SUBJECT: Wake/Franklin Counties; US 401 (Rolesville Bypass) from NC 96 to SR 1103; Federal Aid No. STP-401(249); State Project 8.1403001; WBS # 34506.1.1; **TIP R-2814C.**

Attached are the most recent modification of the US Army Corps of Engineers Individual Permit, N.C. Division of Water Resources (NCDWR) Water Quality Certification, and Neuse & Tar Pamlico Buffer Authorization. All environmental permits have been received for the construction of this project.

Subject: Modification to the 401 Water Quality Certification Pursuant to Section 401 of the Federal Clean Water Act, NEUSE & TAR-PAMLICO BUFFER RULES, and ISOLATED WETLANDS PERMIT Pursuant to IWGP100000 with ADDITIONAL CONDITIONS for Proposed improvements to US 401 in Wake & Franklin Counties, Federal Aid Project No. STP-401(249), State Project No. 81403001, TIP R-2814C NCDWR Project No. 20090104 ver. 6

WETLAND AND STREAM IMPACTS REVISED: MARCH 9, 2018 **

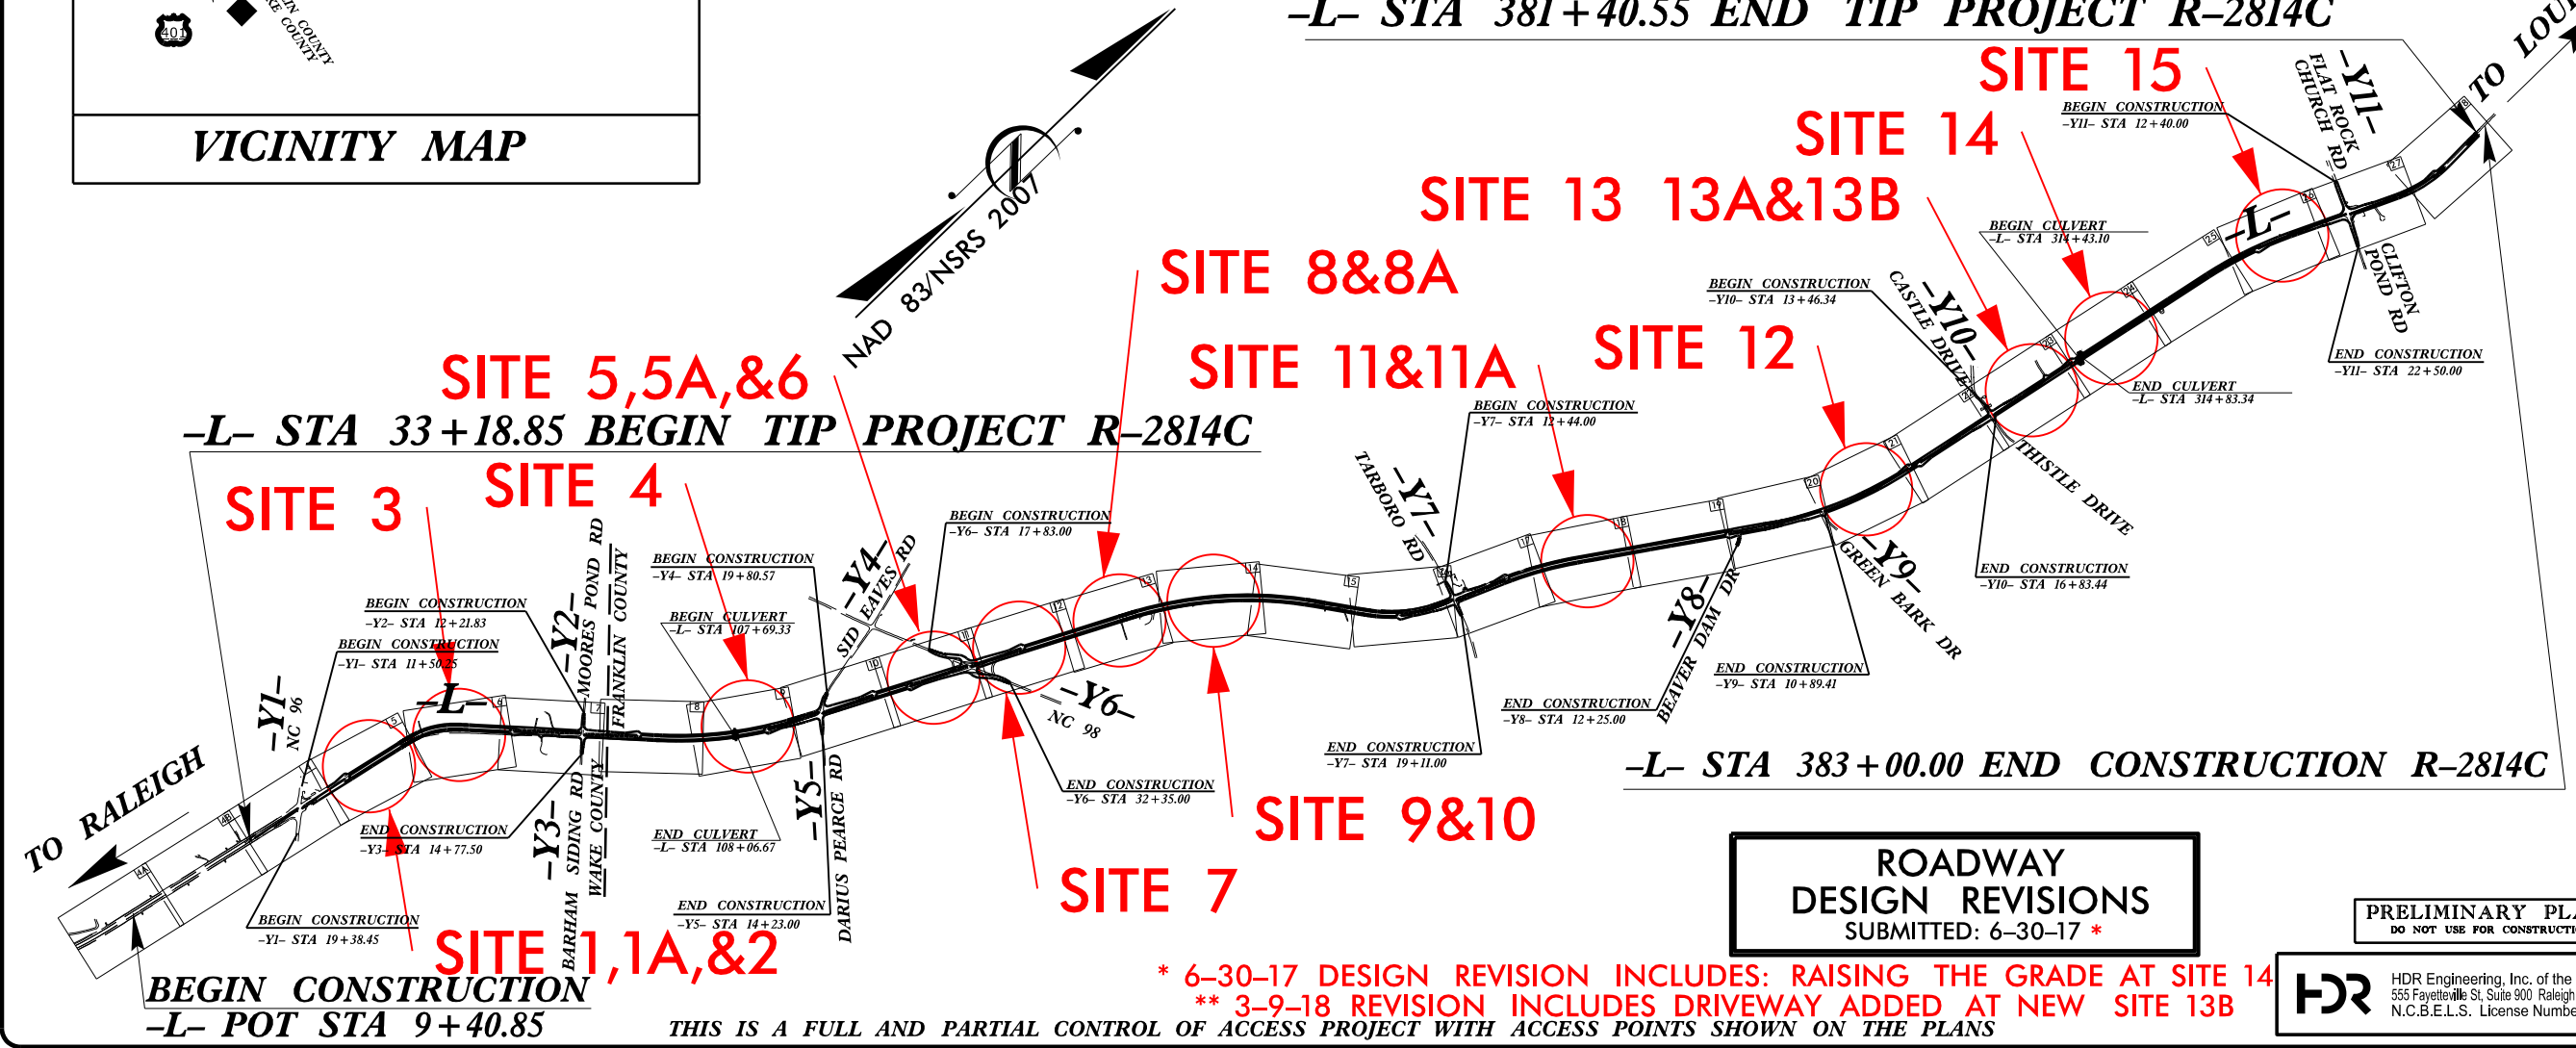
* 6-30-17 DESIGN REVISION INCLUDES: RAISING THE GRADE AT SITE 14
** 3-9-18 REVISION INCLUDES DRIVEWAY ADDED AT NEW SITE 13B

PERMIT DRAWING
SHEET 45 OF 61

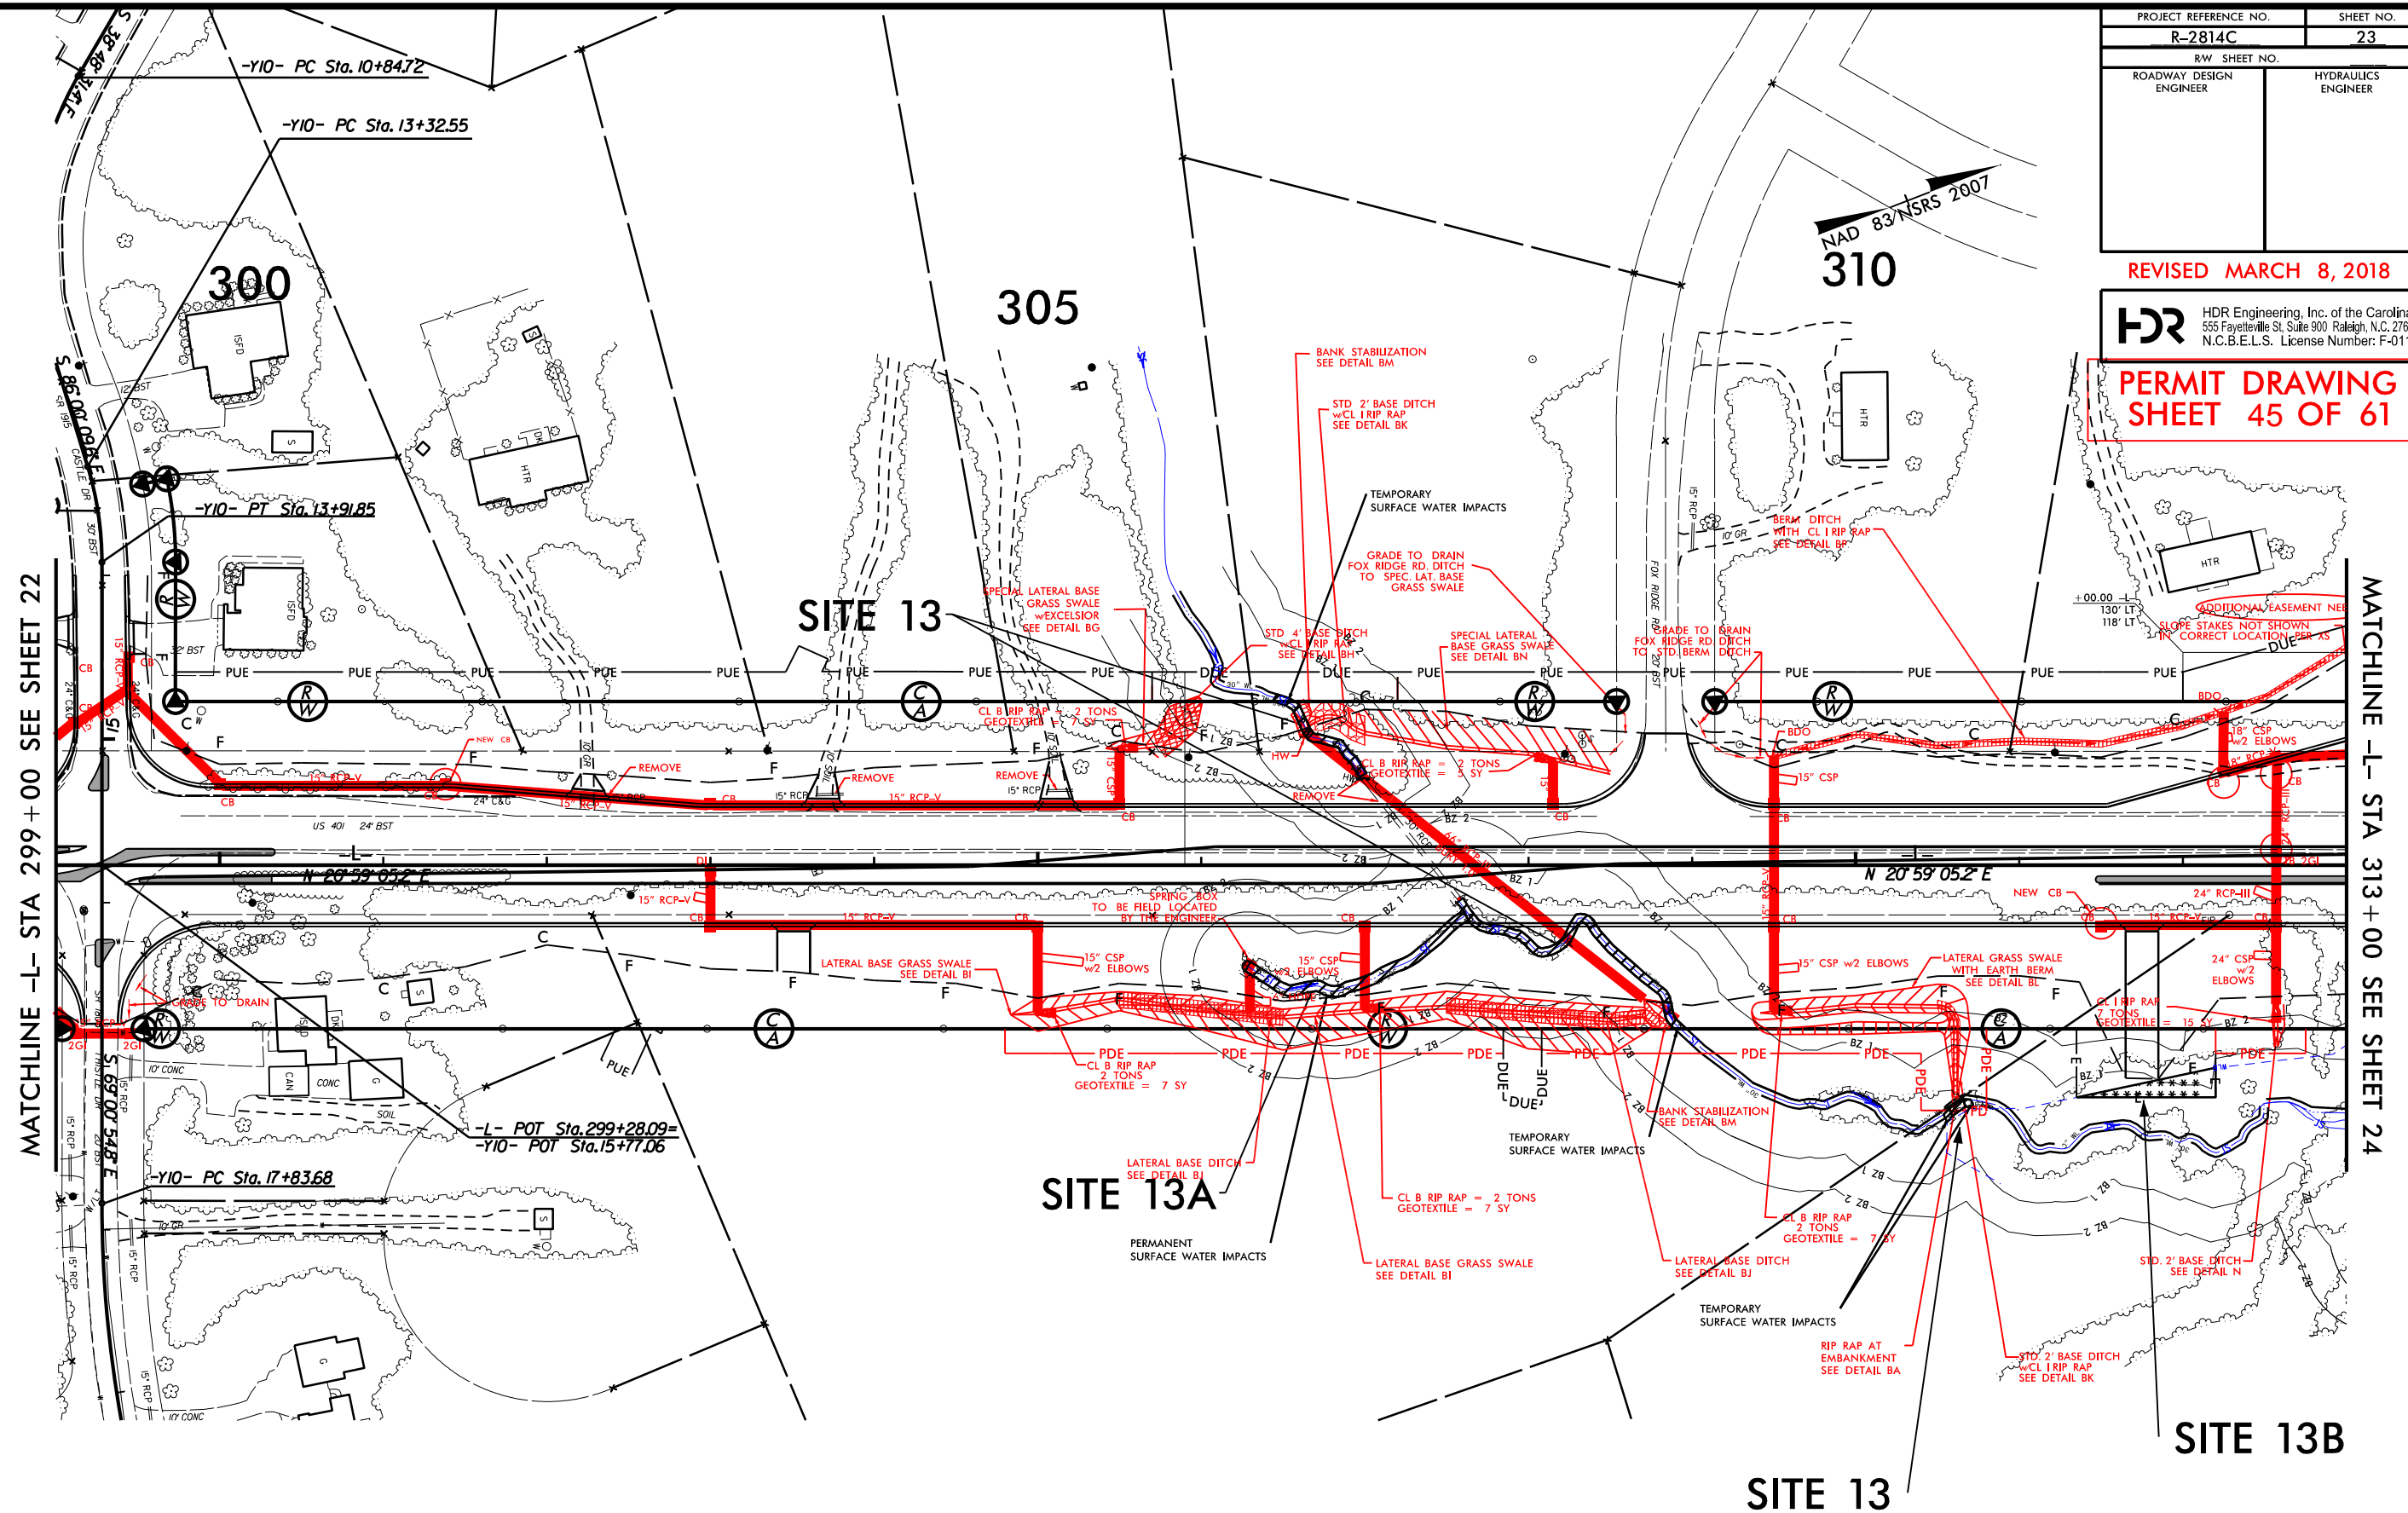
MARCH 9, 2018 REVISION INCLUDES
NEW SITE 13B ADDED FOR NEW DRIVEWAY
